**ADDENDUM NO. 4**

Project Name: **Glenlake Pump Station Bypass Improvements**

C.I.P. No. **2006.024** IFB No.: **6100 CLMC787**

INSTRUMENTATION AND SCADA  
 PRESSURE POINT NO. 72  
 PROCESS AND INSTRUMENTATION DIAGRAM

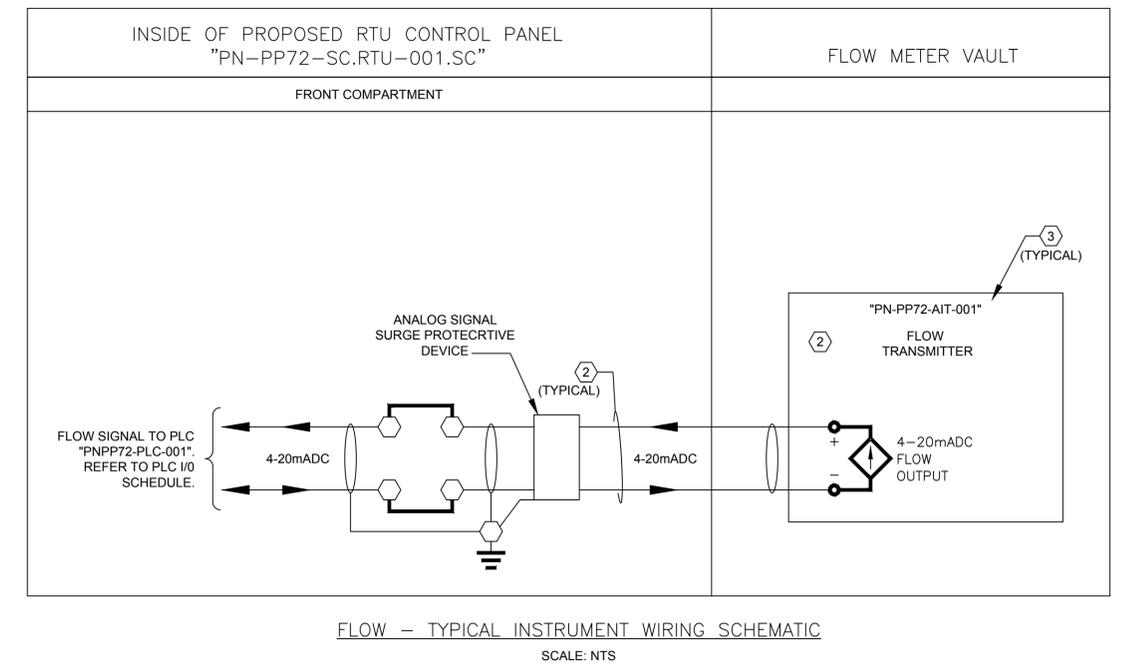
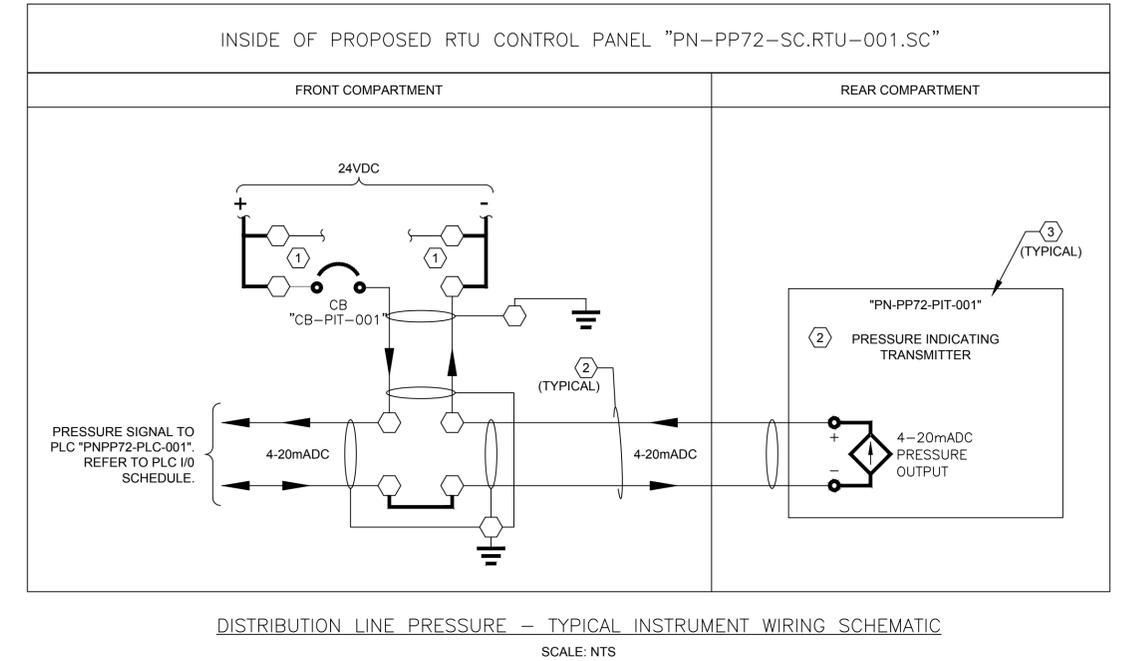
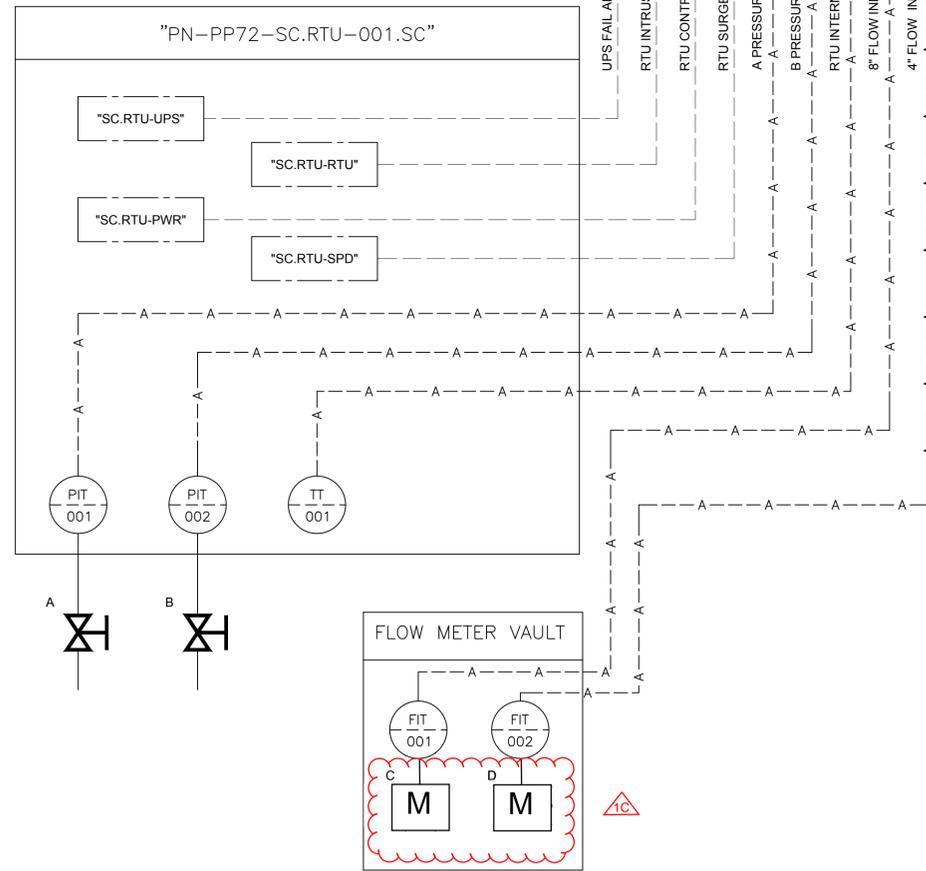
- A. Project Manual Revisions:
- B. Drawing Revisions:
  - Replace sheet IG-3 (52 of 55) with the attached sheet IG-3:
  - Revise the symbol in FLOW METER VAULT

REV. NO.	DATE	DRWN	CHKD	REMARKS
1C	4/9/2020	TC	DF	ADDENDUM NO. 4 - REVISE THE SYMBOL IN FLOW METER VAULT
